AMENDMENTS TO THE DRAWINGS

REMARKS

DRAWINGS

FIG 6B

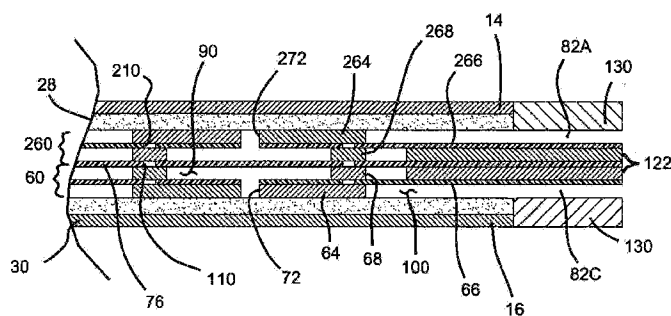
In the Replacement Sheet 7/8 (FIG. 6B), the reference number 108 (adjacent face of the diffusion medium 30) has been added in place of the former reference number 102.

The reference number 108 (in place of reference number 102) is located at the bottom, right of the figure. Support for this change can be found in Paragraph [0037]. Additionally, the reference number 122 (frame) has been added to FIG. 6B. Support for this addition can be found in the application as originally filed. In particular, support can be found in FIG. 6A and amended Paragraph [0037].

Further, the Examiner states that Claim 8 is unclear as to how the frame 122 is interposed between said first gas-impermeable element 66 and said second gas-impermeable element 76. Applicants have submitted

Replacement Sheets, including changes to FIG. 6B, showing the location of the frame 122 between the first gas-impermeable element 66 and the second gas-impermeable element 76. Additionally, Applicants have amended Paragraph [0037] to more clearly describe the location of the frame 122 between the first gas-impermeable element 66 and the second gas-impermeable element 76. For example, Paragraph [0037] describes that “the frame 122 may be laminated between the first sheet 66 and the second sheet 76 and may circumscribe the pillars 68.”

FIG. 3

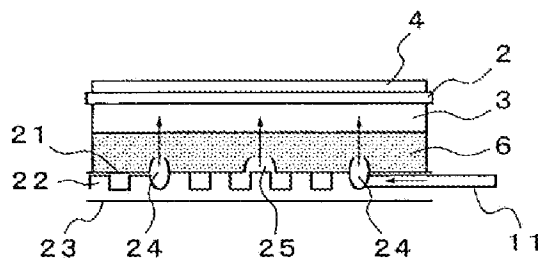
Applicants note that Komada discloses a hollow separator 8 formed by a three-layer structure including a metal upper plate 21, and intermediate plate 22 and a lower plate 23. See Komada at Col. 8, Lines 37-63. The gas discharge openings 24, 25 in upper plate 221 supply fuel gas to the fuel electrode

current collector 6, which faces the separator 8. See Id. and FIG. 3. Fuel gas discharged from the gas discharge openings 24, 25 can be spread to a fuel electrode layer 3 with distribution through the fuel electrode current collector 6. See Komada at Col. 9, Lines 15-18. Gas is not distributed through the volume defined between intermediate plate 22 and lower plate 23. As such, Komada does not teach or suggest a first planar manifold and a second planar manifold.
